STAFF REPORT 05-08-2024 REGULAR MEETING

APPLICATION NUMBER: HDC2024-00183

ADDRESS: 64 EDMUND PLACE

SCOPE: ERECT REAR ADDITION AND ROOF DECKS, RESTORE FULL-WIDTH FRONT PORCH, INSTALL WINDOWS

Architectural elevations from applicant materials (left image – front, right image – rear, below- side elevation). Not to scale.

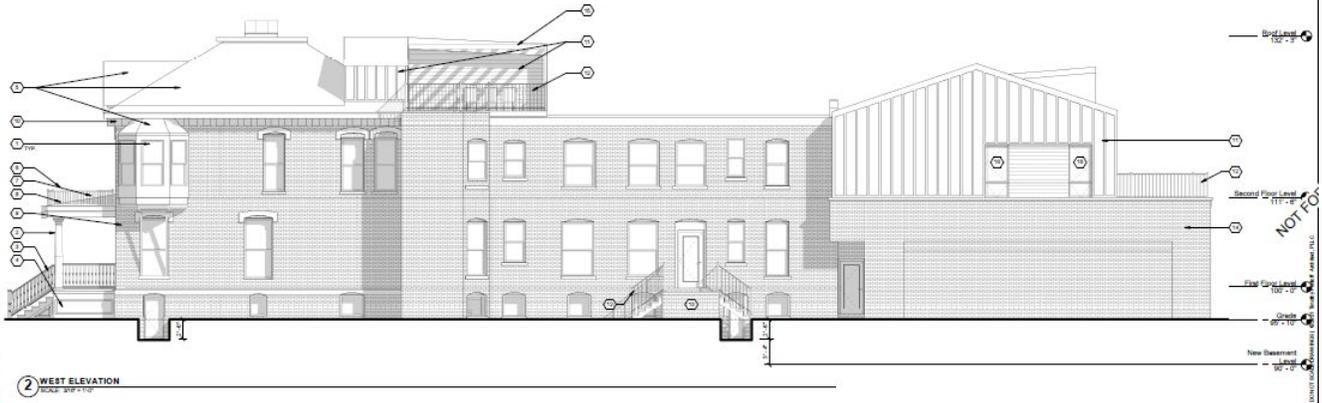
- Staff finds that the monumental and architectural chimneys on the original mansion portion are important historic elements that should be retained.
- Staff suggests that the design of the “doghouse” elements be revised/reduced further, possibly by introducing transparency or restoring previously present historic elements, to prioritize the expression of historic fabric and reduce the impact of the new elements.

- The window product selected, the Andersen 400 series, is a vinyl-clad wood single-hung product, which exhibits neither the robustness nor finished appearance necessary for compatibility with the nineteenth century detailing critical to this building’s dominant architectural and historic expression. Windows at the building’s important historic elevations should be true wood or aluminum-clad wood, double-hung in operation.

- Staff also questions the configuration of the 1st floor windows at the main (front) façade, and recommends that they be reconfigured in a vertically oriented traditional form based on either Italianate or Colonial Revival precedents, not as casements/fixed units.

- The four chimneys on the main house be repaired and preserved
- The "doghouse" elements housing the new stairs to the mid-building roof deck be redesigned to be less obtrusive, via internal reconfiguration of the stairs, the introduction of glass planes to allow greater transparency through the elements, and/or reintroduction of a rooftop balustrade as seen in historic photographs
- Window product selection and configuration throughout the rehabilitated areas of the building will be true wood or aluminum-clad wood units, with vertically-oriented double-hung configuration compatible with Italianate or Colonial Revival examples. A new front elevation depicting revisions to the first floor front-facing windows shall be submitted.

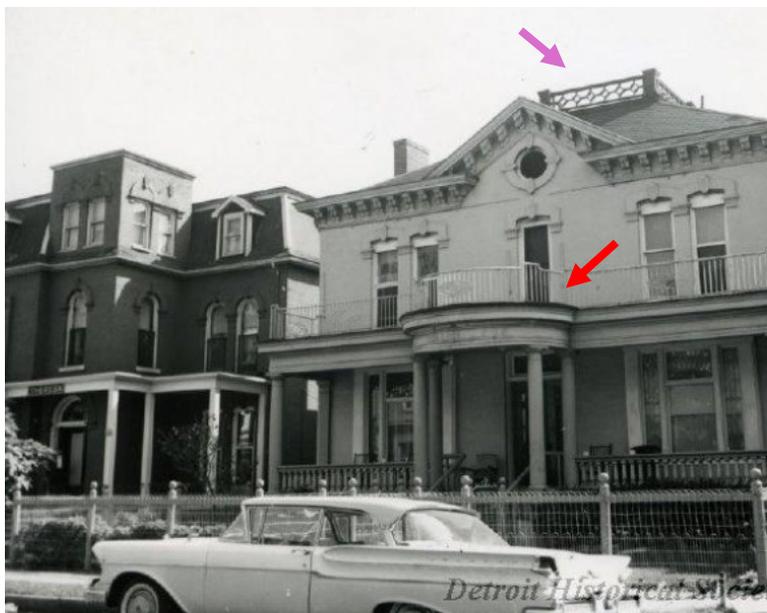
- The front porch of this house has existed in at least four different iterations over the last 150 years. The original Victorian era porch, as rendered speculatively on page 2 of this report, was removed early in the historic period. The second porch, shown below, was a grandly stylized Colonial Revival full-width porch with six columns and a balustrade, centered by a curved projection over the main entrance. It was likely added at the same time as the “rooming” addition, and would have served as a welcome exterior social space for the various working residents of the building. In 1978, just prior to the district’s designation, the Colonial Revival porch was simplified by removing the curved portion. While likely done for maintenance purposes, this alteration of the porch’s rooflines returned more balance to the juxtaposition between the 19th and 20th century expressions of the house, in staff’s opinion. Finally, the remainder of the historic 20th century porch was removed in the late 20th century and replaced with a small utility porch of no historic character, which survives today.

The applicant proposes to reconstruct a close facsimile of the early 20th century Colonial Revival porch that existed *at the time of designation* (without the curved projection), in compatible and authentic wood materials, based on surviving photographs from the 1960s through the 1980s. There is no record of Commission approval for removal of the Colonial Revival porch which was present in 1980. Staff recommends this treatment as historically appropriate, and also as a remedy for this apparent violation, as it returns the porch to its appearance at the time that regulatory controls commenced.

- Restoring the long lost rooftop balustrade (also visible in the 1963 photo above), which would restore another authentic historic element to the roof (along with retaining the chimneys) that might reduce the impact of the “doghouse” elements.
